PROJECT **123A90 - HOLLANDSE KUST NOORD WIND PARK**
BLPH Project

MECHANICAL COMPLETION DOSSIER (ONSHORE)

Junction Box 950-JE-03103 and Multi-core cable (FGS System)

TB-950-JE-03103

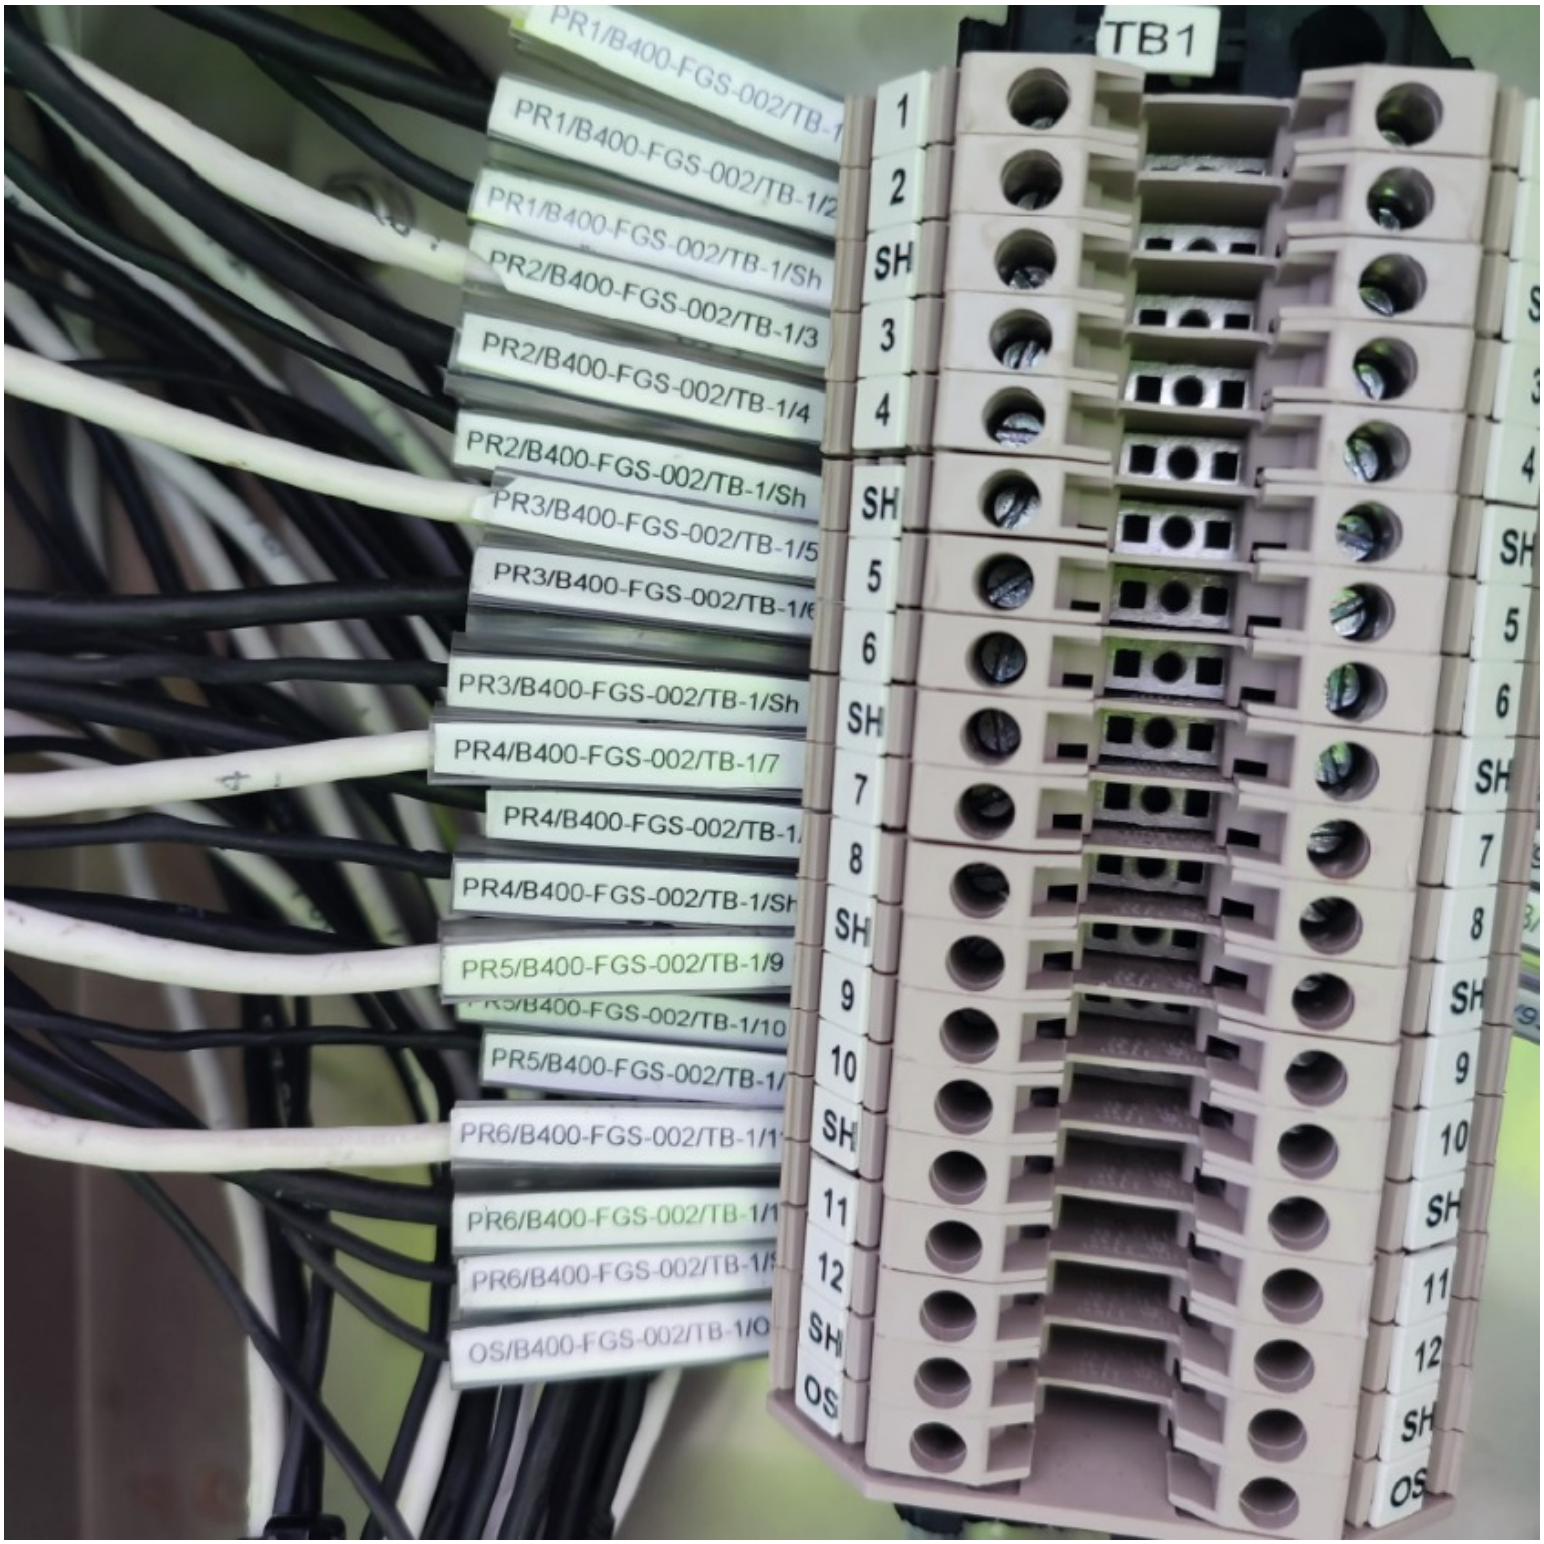
Identification tag wires is wrong written the Marshalling cabinet , side the (950-JE-03103).

Installed.
